DUKE POWER COMPANY

Re: Catawba Nuclear Station
Docket Nos. 50-413 and 50-414

Attached are revised Requests for Relief CN-1-001 and CN-1-002. A copy of CN-1-003 is also attached for completeness. No additional Requests for Relief on Unit 1 are expected.

DUKE POWER COMPANY
Request for Relief from
Inservice Inspection Requirement

DRWG NO. CN-1491-SM003 PRESS. 1185 PSI. TEMP 600 F. WT. 80185 LBS.

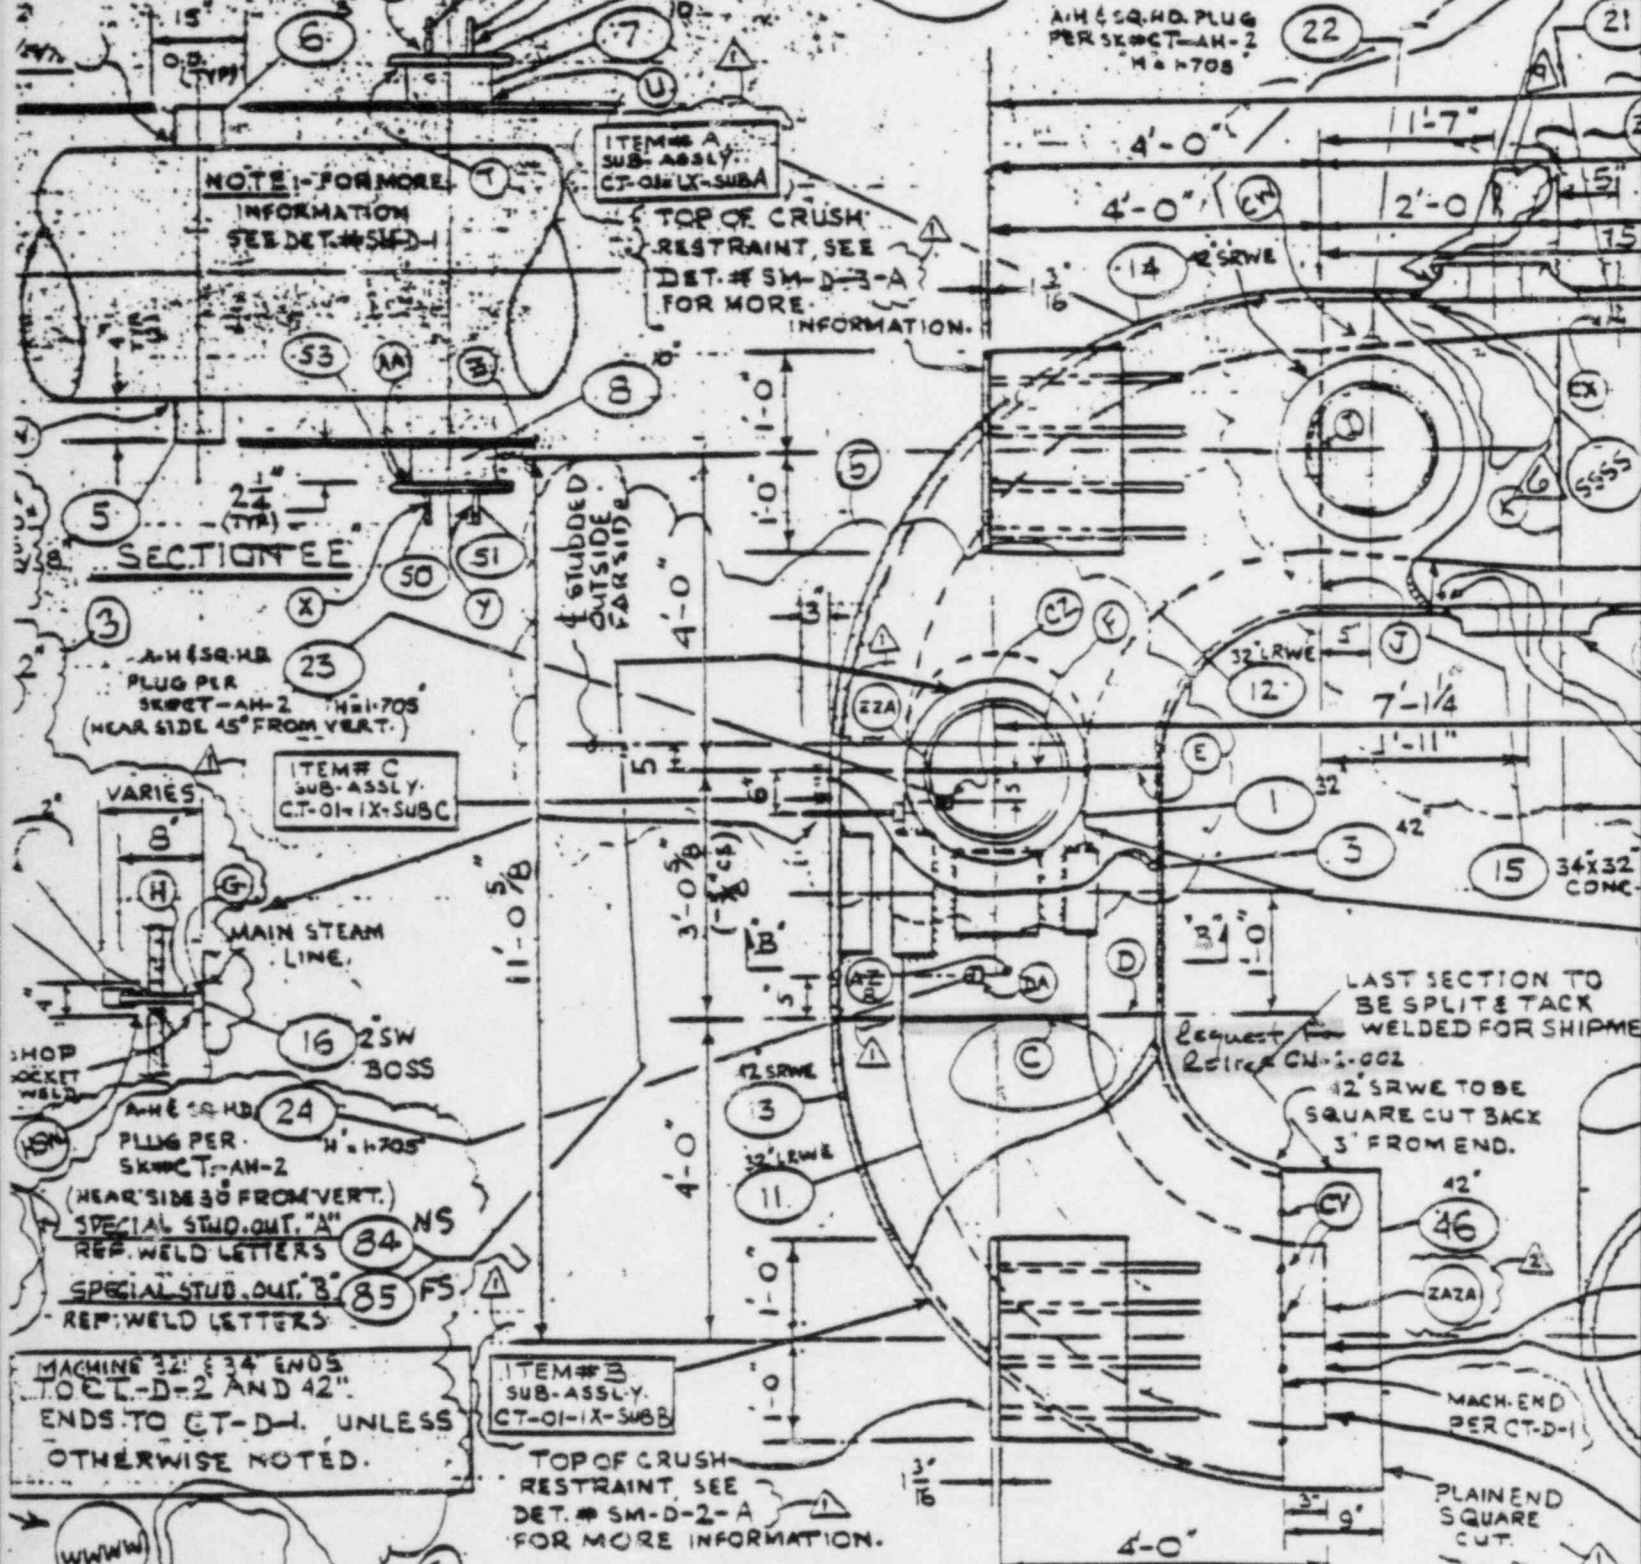
The following is a list of circumferential butt welds for which volumetric examination has been determined to be impractical:

<u>Assembly</u>	<u>Weld Number</u>	<u>Size</u>
A Generator: Main Steam	CT-SM-1A-C	32"
B Generator: Main Steam	CT-SM-1B-C	32"
C Generator: Main Steam	CT-SM-1C-C	32"
D Generator: Main Steam	CT-SM-1D-C	32"

There are no alternate examinations that can be performed due to the inaccessibility of the welds.

The fabrication radiography records will be used in lieu of the on site preservice inspection examination.

FIG. IWB-2500-13 INTEGRAL ATTACHMENT WELD

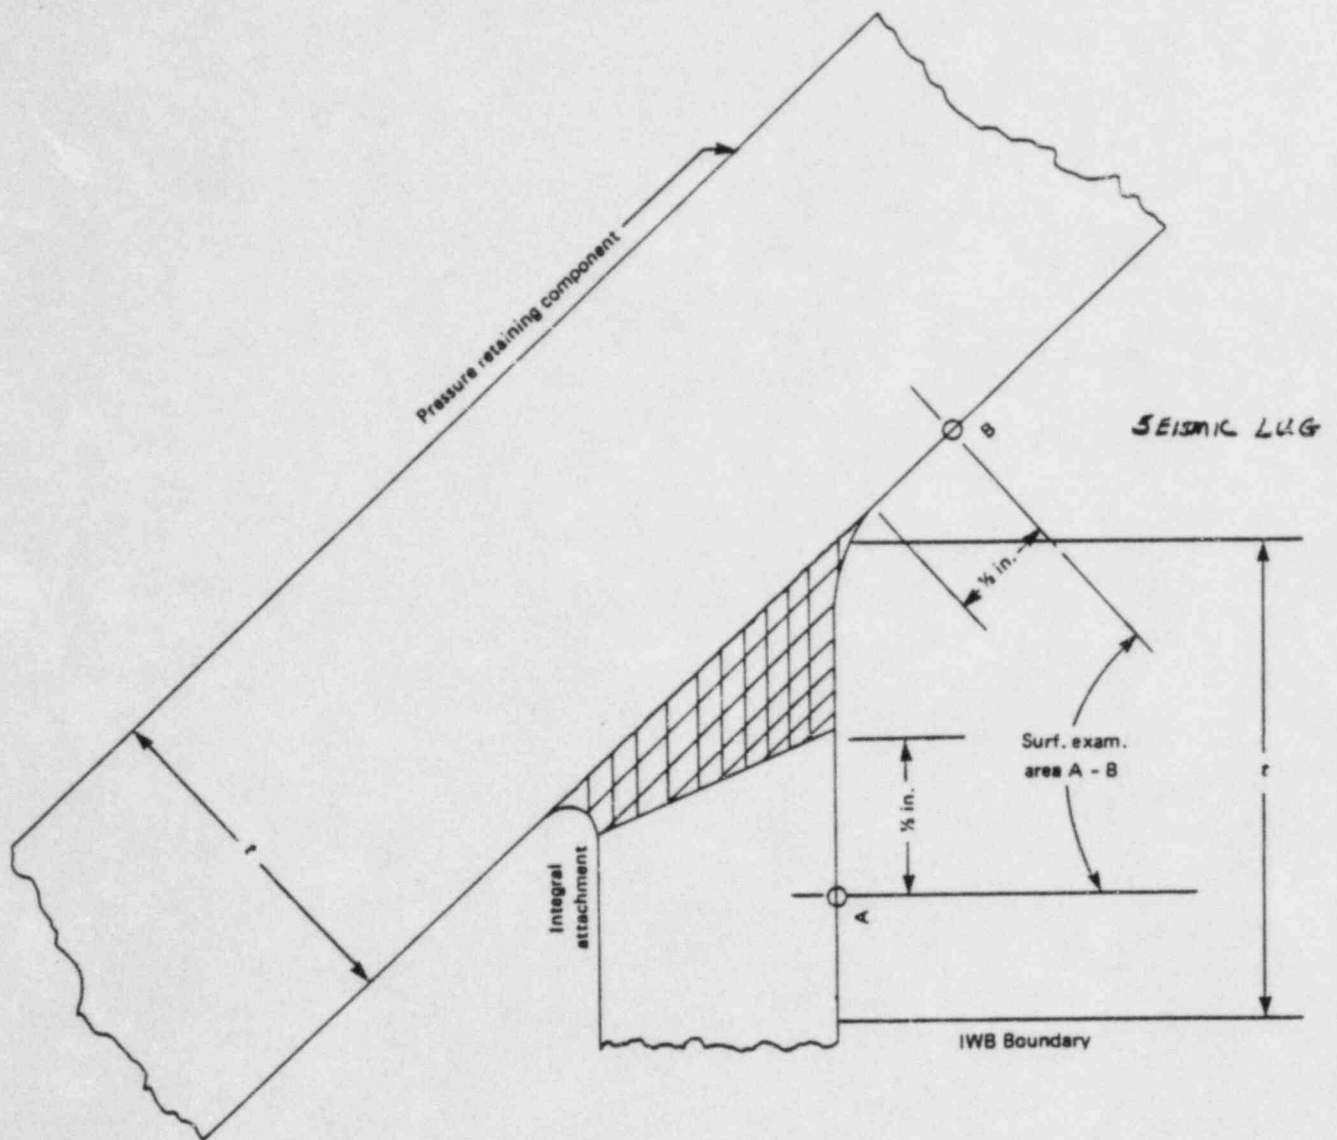
Section XI Table IWB-2500, Examination Category B-H, requires that 100% of all support lug attachments to Class 1 Vessels shall be examined. Section XI Table IWB-2600, Item #B2.8, requires volumetric examination for integrally welded vessel supports.

Reference figure #'s - IWB-2500-13
IWB-2500-15

Surface examination will be performed on all seismic lug
and support bracket welds to the Class 1 pressure boundary.
